**AMENDMENTS TO THE DRAWINGS:**

The attached drawing sheet includes amendments to FIGS. 1A-3C. These sheets replace the original sheets including FIGS. 1A-3C. Marked copies of amended FIGS. 1A-3C are also enclosed.

Serial No. 10/597,306

Docket No. NEC 04P199

Fig. 1A PRIOR ART

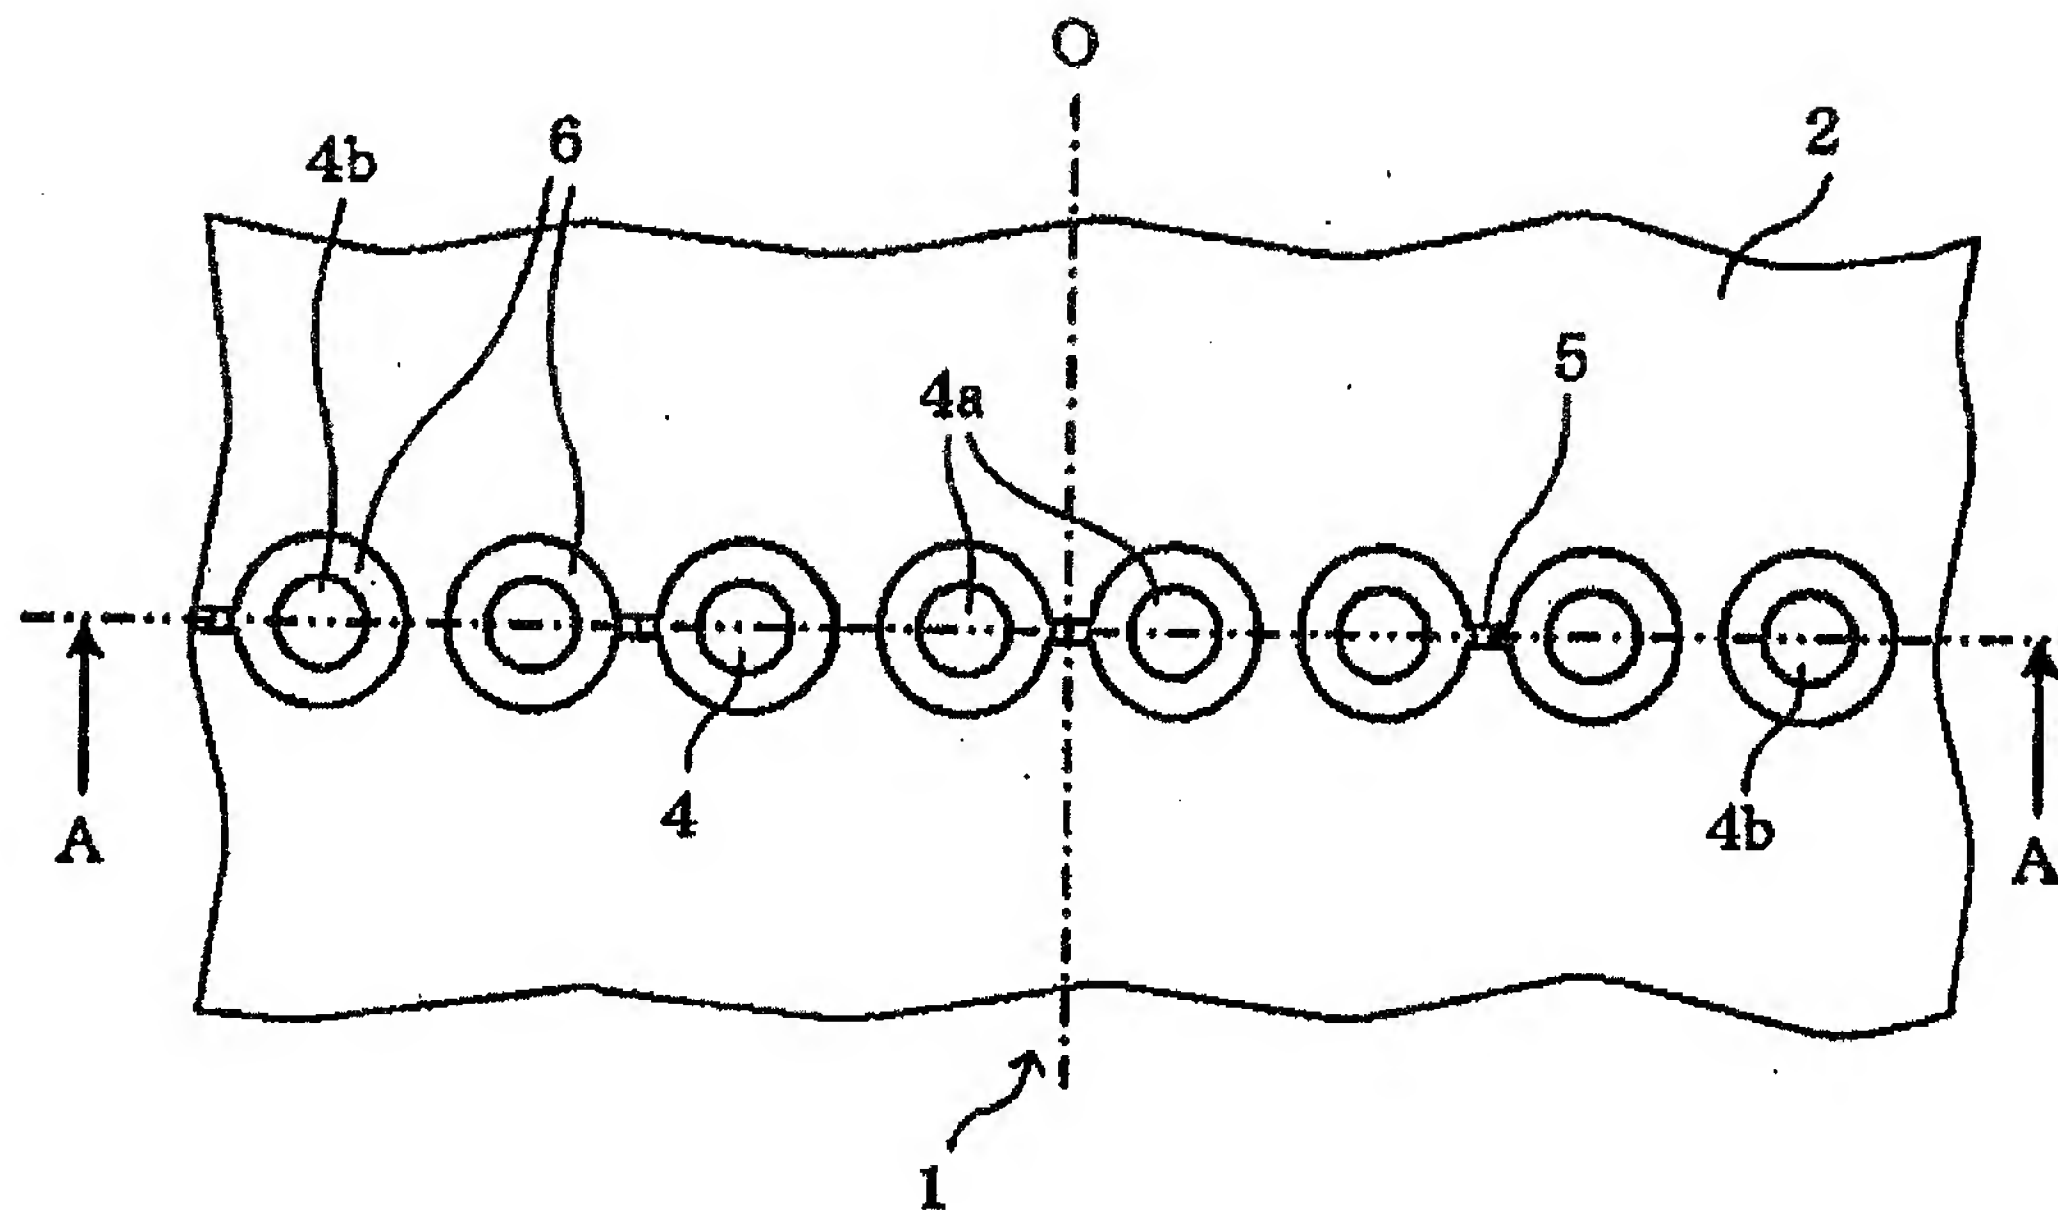
Claims 1, 4, 5 and 9 have been amended to more closely conform to U.S. claiming practice. The abstract and drawing FIGS. 1A-3C have also been amended. No new matter has been entered by any of the foregoing amendments.
